Groundwater Application Review Summary Form

Application # G- 18299 Re. review

SUBJECT: Application G- 18299 Supersedes review of 12/27/2016
Date of Review(s)

A1. Applicant(s) seek(s) 0.673 cfs from 2 well(s) in the Willamette Basin,
Pudding River subbasin

Figure 1: Water level data for a nearby well showing similar head elevations to that expected within proposed POA wells.

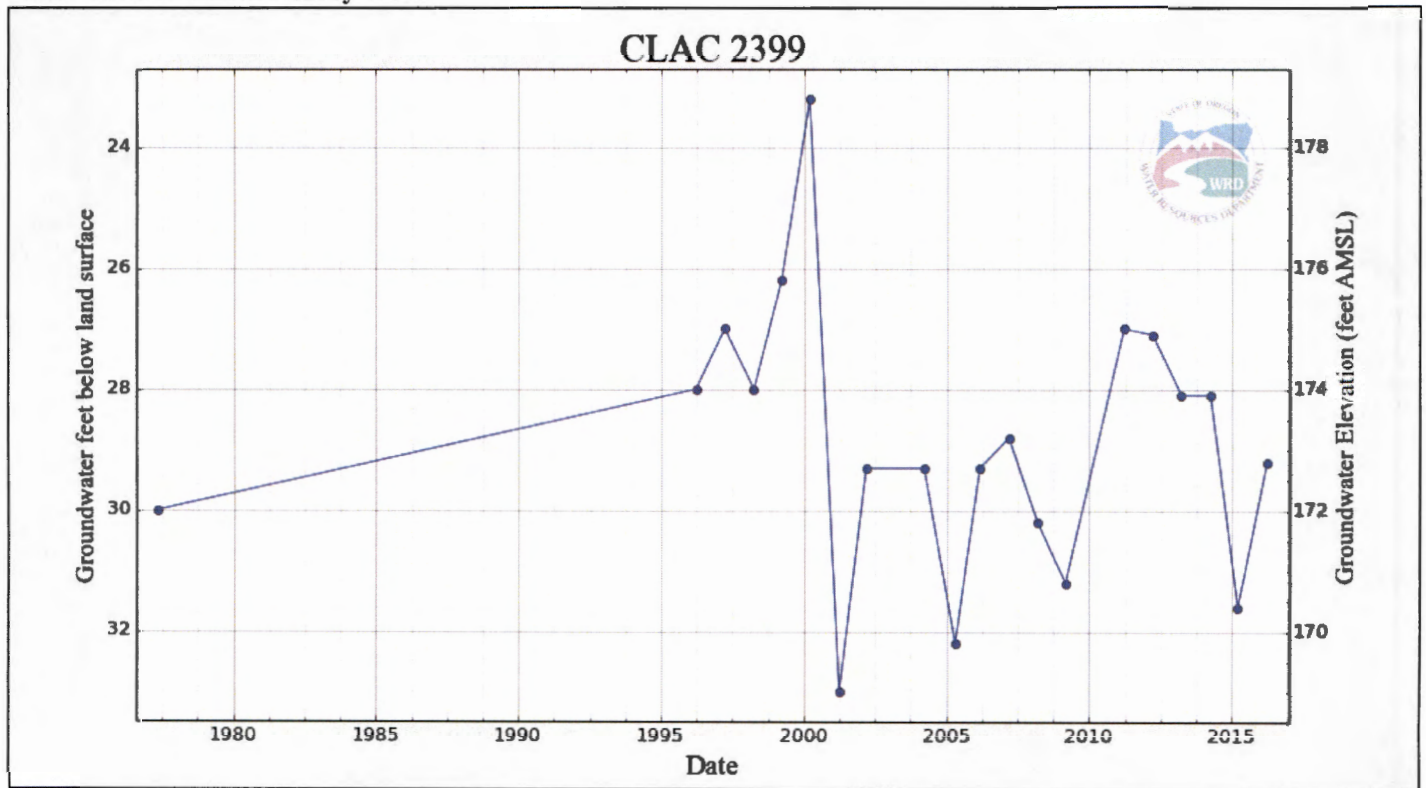
- B3. **Groundwater availability remarks:** Area wells with similar head elevations in the alluvial aquifer system show relatively stable water levels for the past two decades (see attached hydrograph). The closest nearby groundwater POA (CLAC 2460 on permit G-15132) is about 250 feet from the proposed location of "Well 2", but develops from a much shallower portion of the aquifer system. This is evidenced on the well log, in addition to a vast difference in head elevations between CLAC 2460 and the applicant's well on which construction of the proposed POA wells is based (~235' AMSL for CLAC 2460 versus ~175' AMSL for CLAC 64676).
- _____
- _____
- _____
- _____
